Model Evaluation Report for Corrective Action Unit 98: Frenchman Flat, Nevada National Security Site, Nye County, Nevada

Revision No.: 1

September 2014

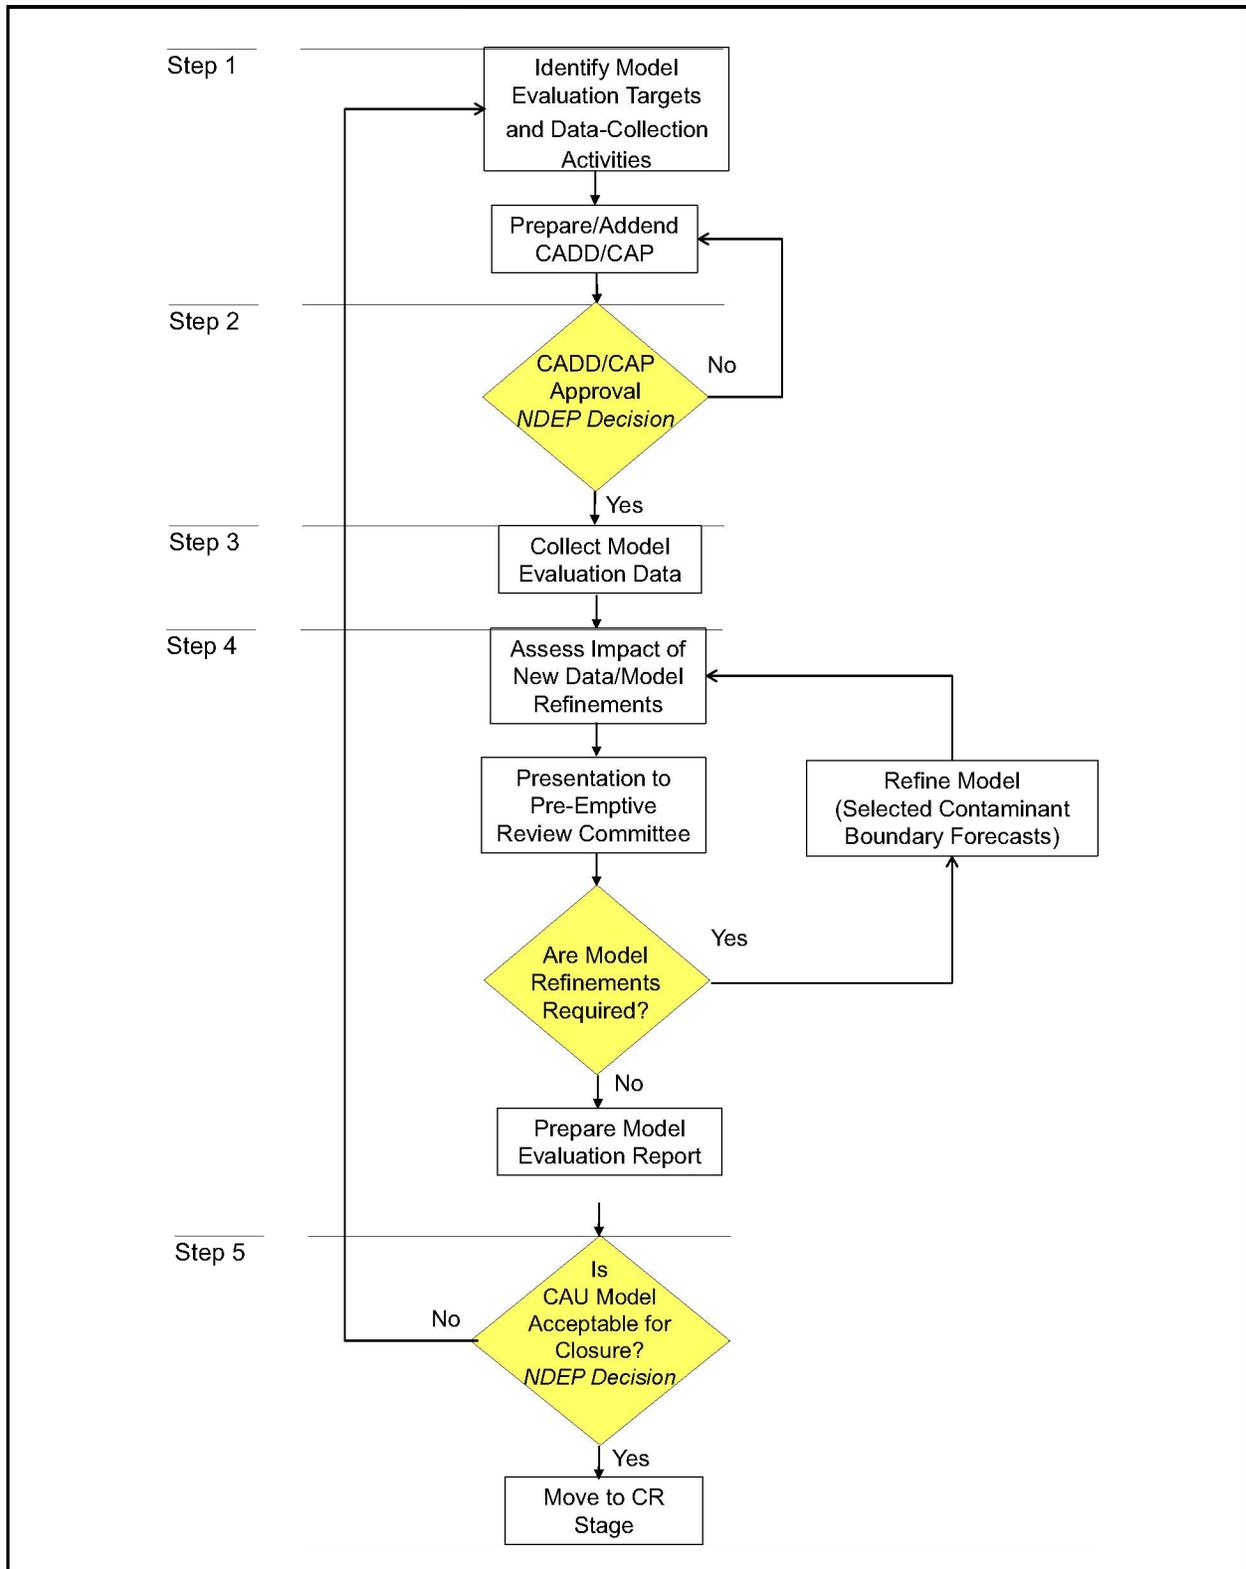
17) Figure 2-1 caption, Section 2.1; page 2-1, Section 3.4; page 3-2, Section 6; page 6-4 [b]	M	Replace Phillips et al. (2011) reference with Phillips et al. (2014): Phillips, J.D., B.L. Burton, E. Curry-Elrod, and S. Drellack. 2014. *A Ground-Based Magnetic Survey of Frenchman Flat, Nevada National Security Site and Nevada Test and Training Range, Nevada: Data Release and Preliminary Interpretation*. Open-File Report 2014-1187. Henderson, NV: U.S. Geological Survey. Phillips et al. (2014) is a USGS Open-File Report rather than a written communication.	Reference has been replaced.

Figure 2-5
West–East Geologic Cross Section through Emplacement Hole U-11b and Well ER-11-2
Source: Modified from NNSA/NSO, 2013b

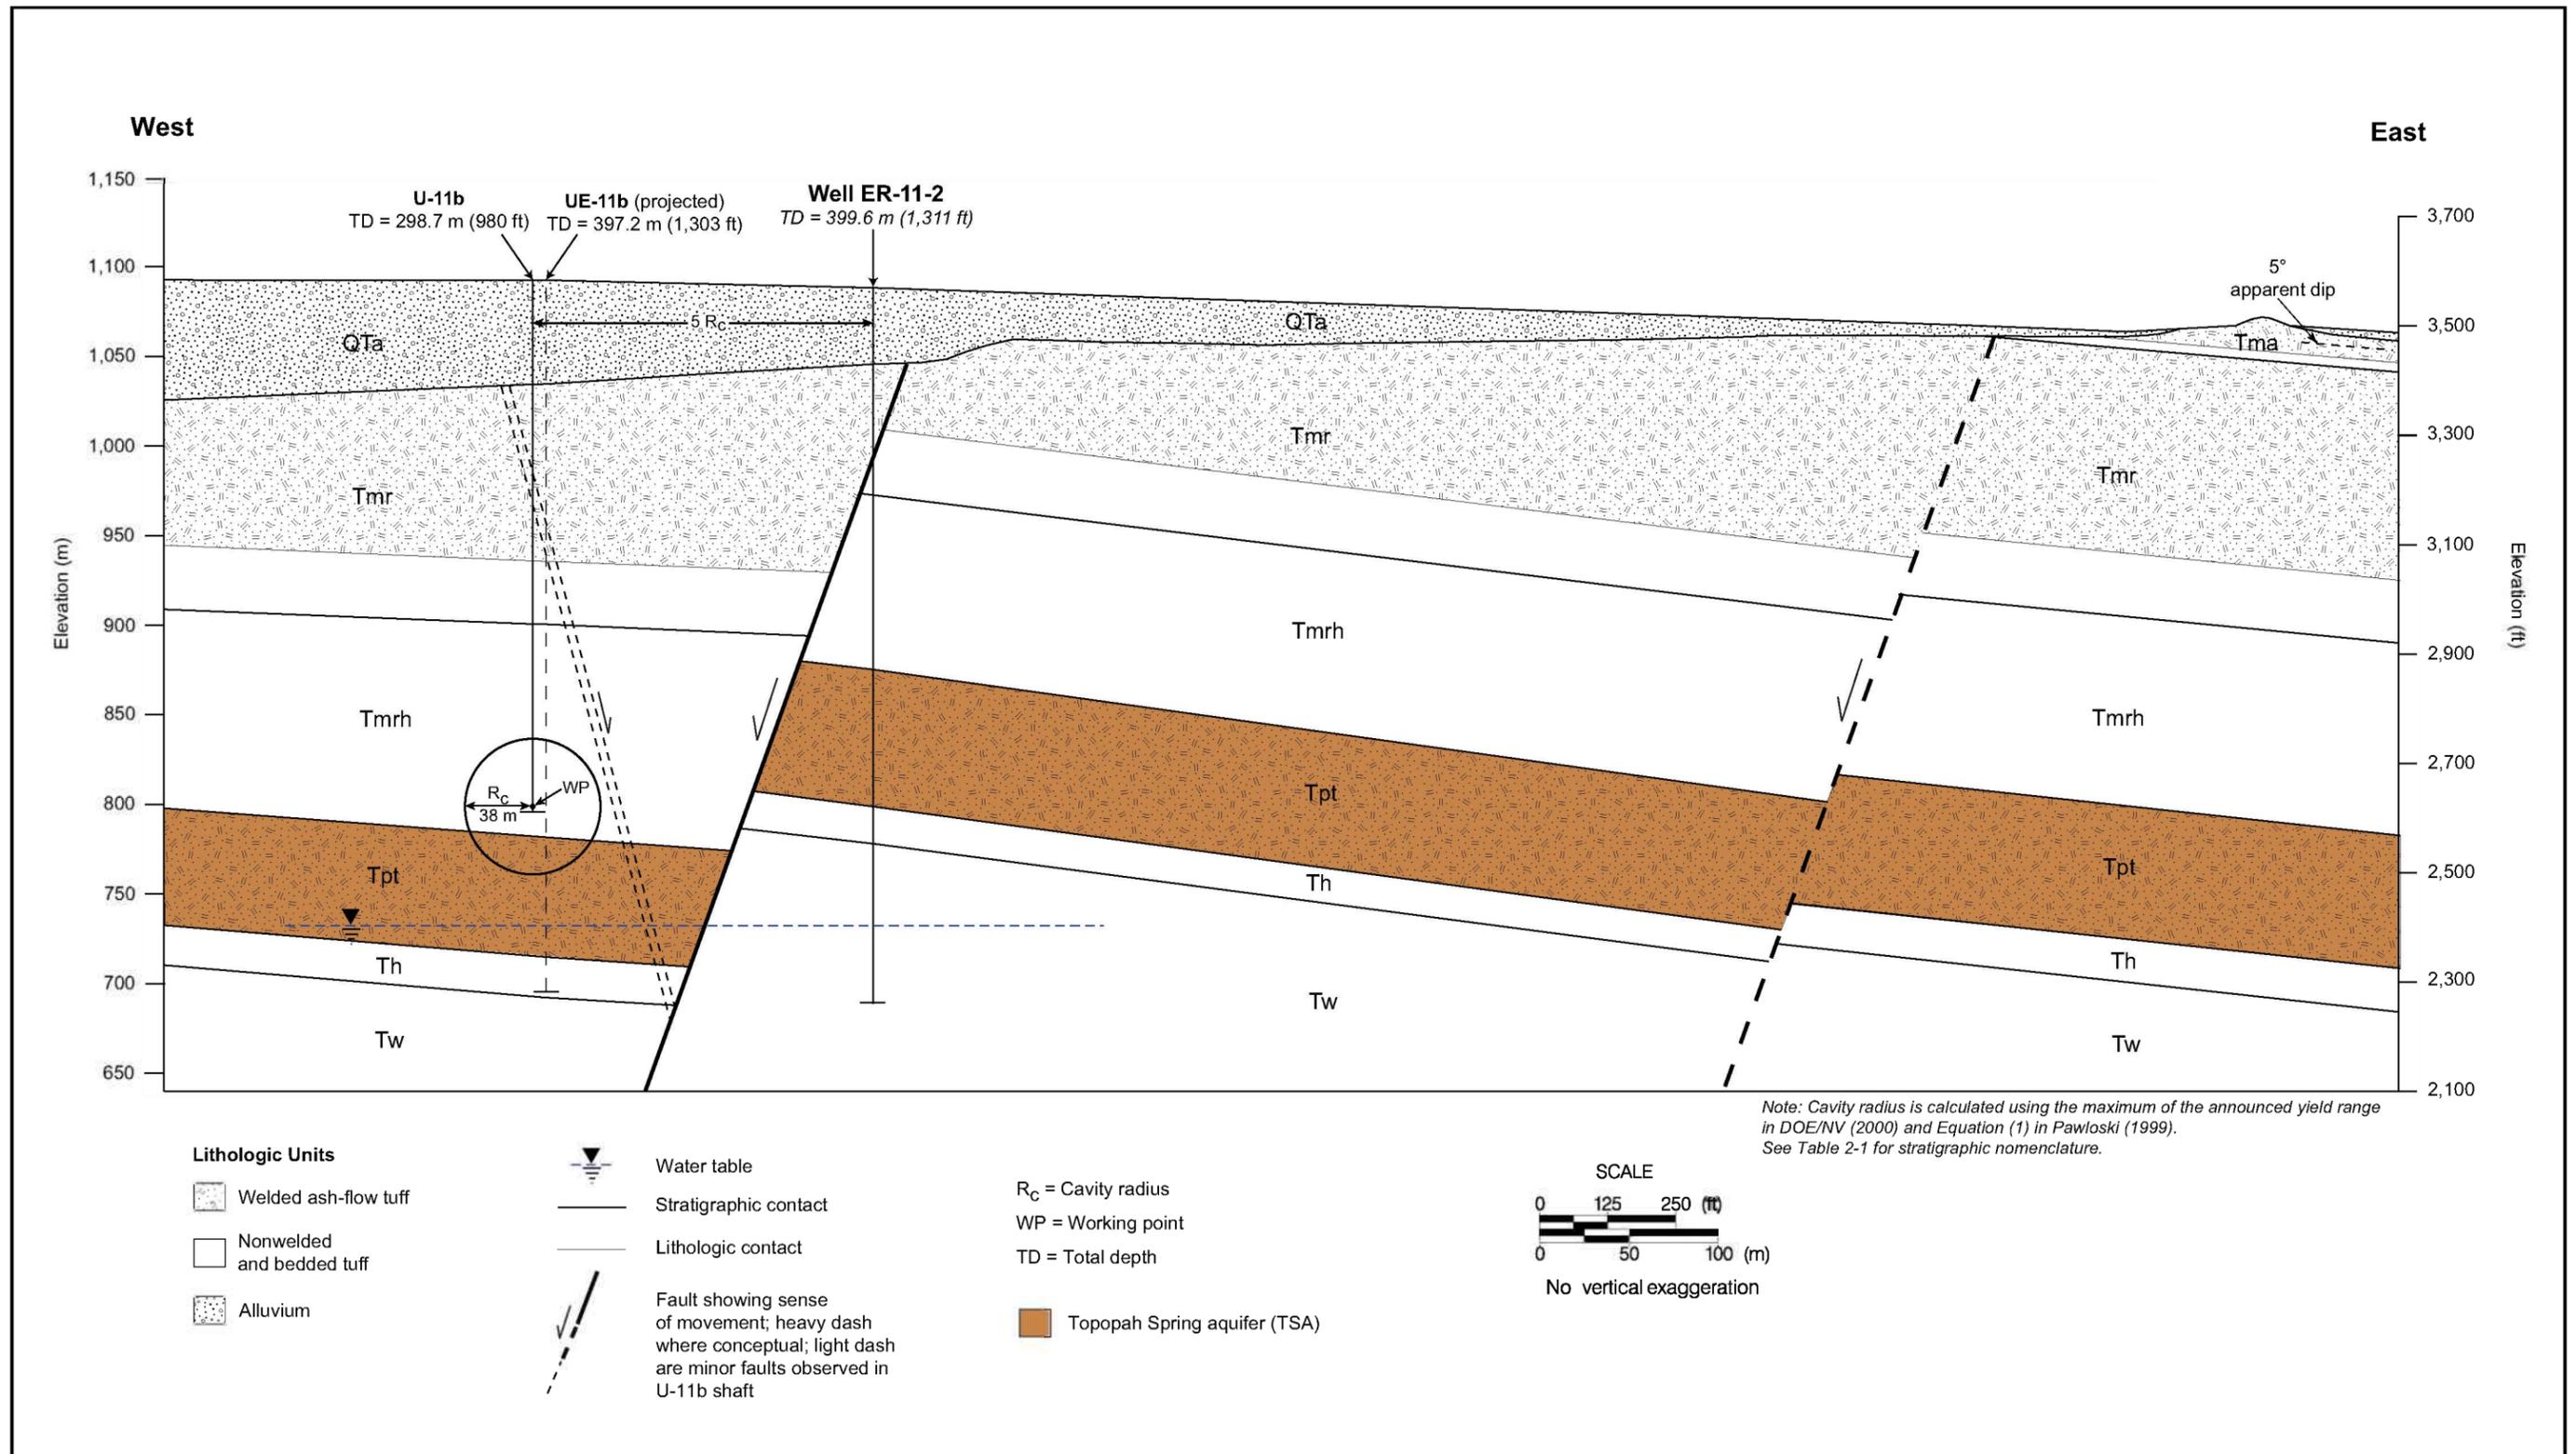
10. Comment Number/Location	11. Type[a]	12. Comment	13. Comment Response	14. Accept/Reject
4) Section 3.5.4, page 3-11	M	Second paragraph, first sentence: "Water levels at Well ER-11-2 are much higher than observed elsewhere in the alluvial basin (see Figure 3-18)." Figure 3-18 only shows information for Well ER-11-2 with no comparison to other well data in the alluvial basin. Is there another figure showing this comparison, or are there other values for the well data in the alluvial basin elsewhere in this report to see how much higher the water levels are for Well ER-11-2? Please clarify this section.	Figure 3-18 illustrates the approximate water table elevation in the alluvium (horizontal dashed blue line at approximately 733.8 m). This line is consistent (value, color, etc.) with the Approximate Water-Table Elevation line shown on Figure 3-5. To improve the clarity of the statement, the static water level for ER 11-2 was added to the text and reference added to Table 3-1 where all static water level values are listed and to Figure 3-2, which shows only the values for the OAA/AA wells. Note that the point of Figure 3-18 is to show the magnitude of the difference between the AA water levels and those observed at ER-11-2 (about 4 m), and other figures and tables provide the supporting data in greater detail. The composite water table map shown in Figure 3-10 posts the ER-11-2 water-level data with the water levels observed at nearby wells. Related to this comment, the dashed line on Figure A-2 has been lowered slightly to represent the groundwater elevation difference observed between ER-11-2 and wells located in the OAA.

Figure 3-3
CAI Model Hydraulic Head Match to CAI Static Water-Level Data
Source: NNES, 2010

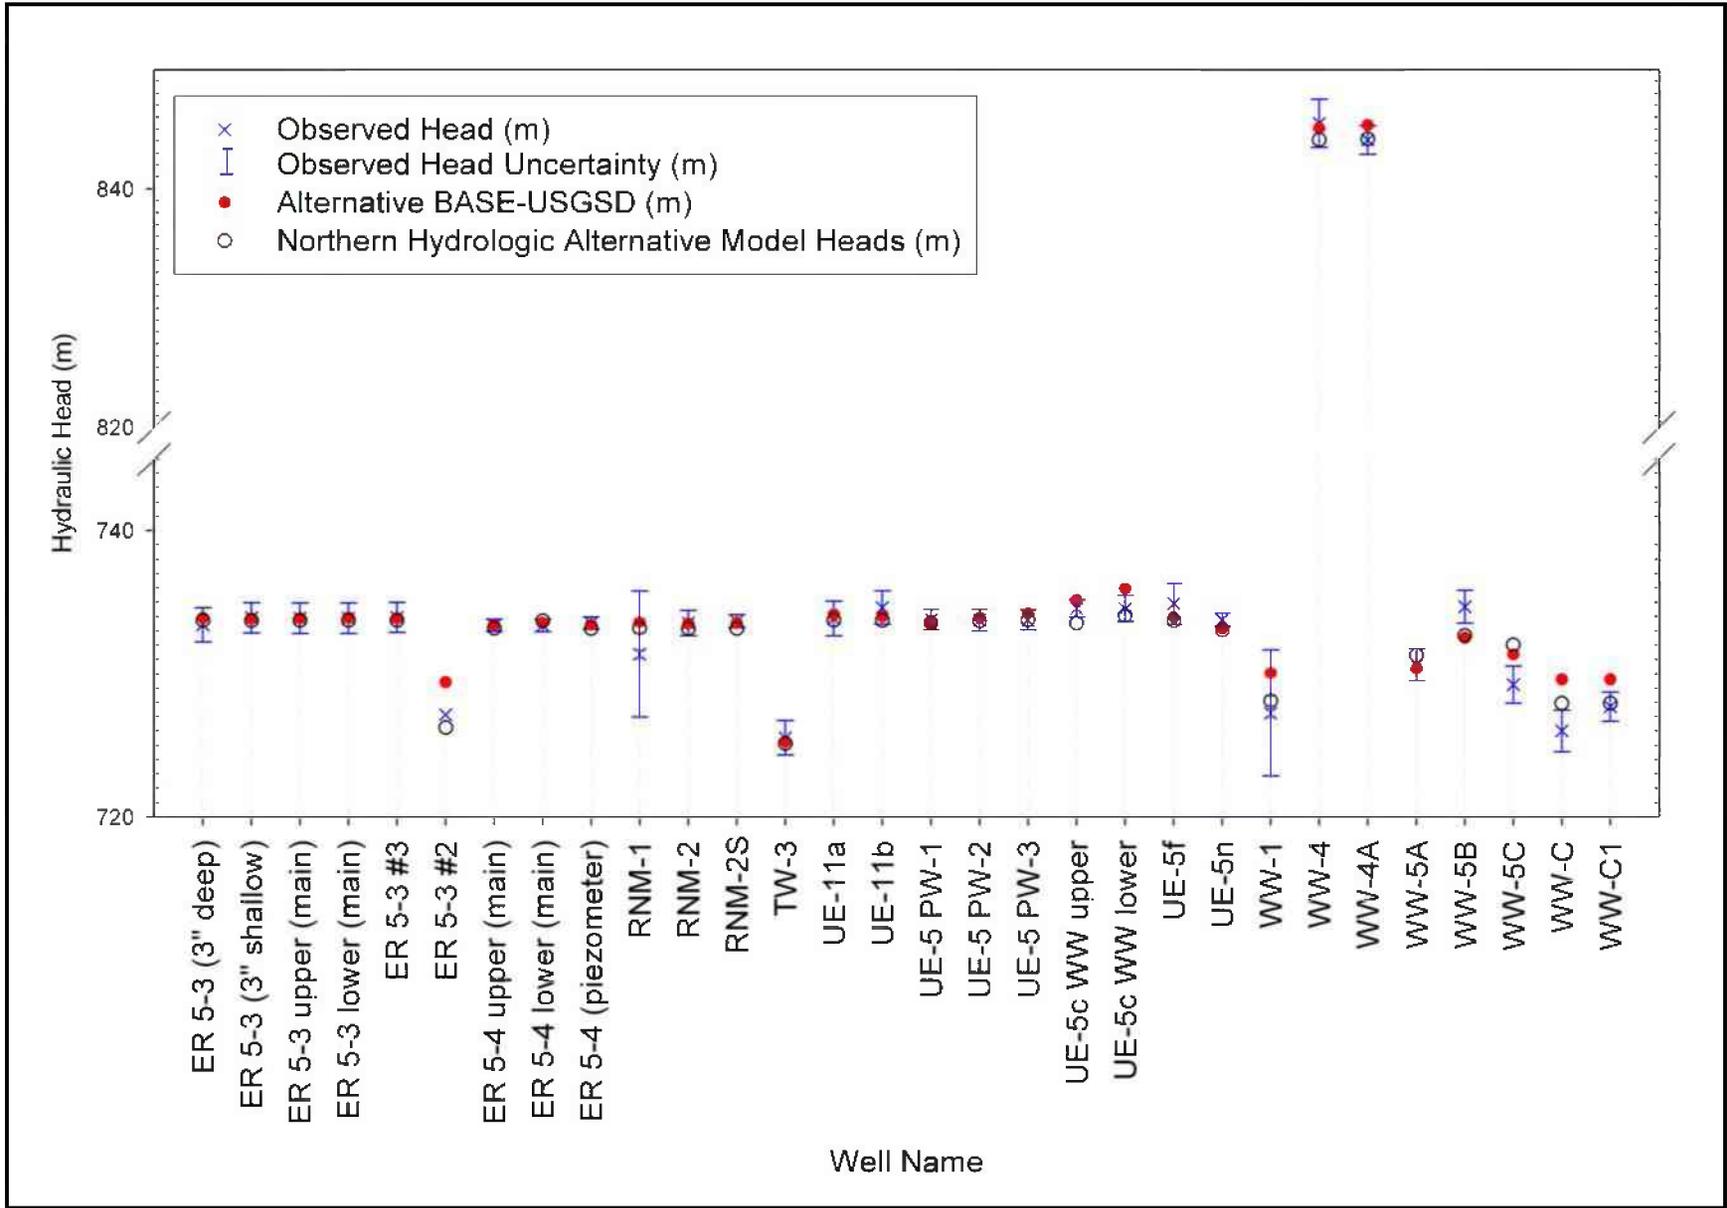
22) Section 3.5.2, page 3.6, Table 3.1 and Section 3.5.3, page 3-9, Figure 3-3[c]	M	The reference for the table is NNES (2010), and while similar plots are provided in that reference the data are not. What is the source of the data and uncertainty shown in Figure 3-3?	The titles for Figure 3-3 and 3-4 were inadvertently switched; the text that describes them is correct. Titles were corrected. Figure 3-3 is directly from NNES (2010), and the target data for this figure (CAI data used for calibration) are described in SNJV (2006) Appendix A and the uncertainty is described in SNJV (2004c). Text was added in Section 3.5.3 (Line 4) after "the CAI static heads" to read "presented in SNJV (2006, Appendix A)". Also, text was added in Section 3.5.3 (line 4) after "and estimated uncertainty" to read "presented in SNJV (2004c)".

Figure A-2
North–South HFM Cross Section through PIN STRIPE

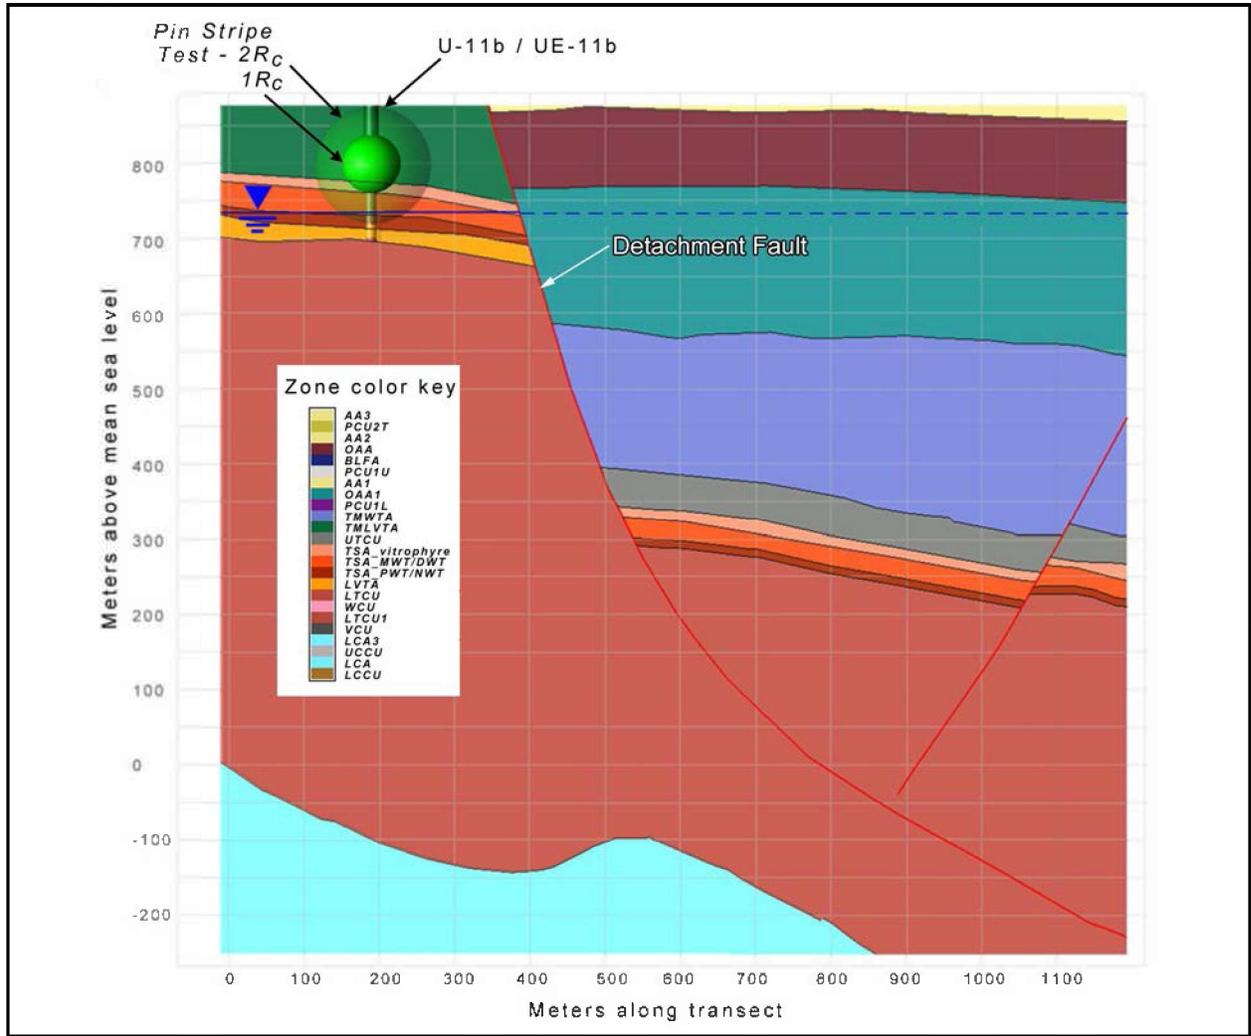
18) Figure A-2 [b]	M	Well names are not UGTA standard.	The well name nomenclature was corrected. For instance, "U11-b" was changed to "U-11b."	
19) Page A-15 [b]	M	The plus or minus one standard deviation on the second line should refer to direction, not porosity.	Changed "porosity" to "direction."
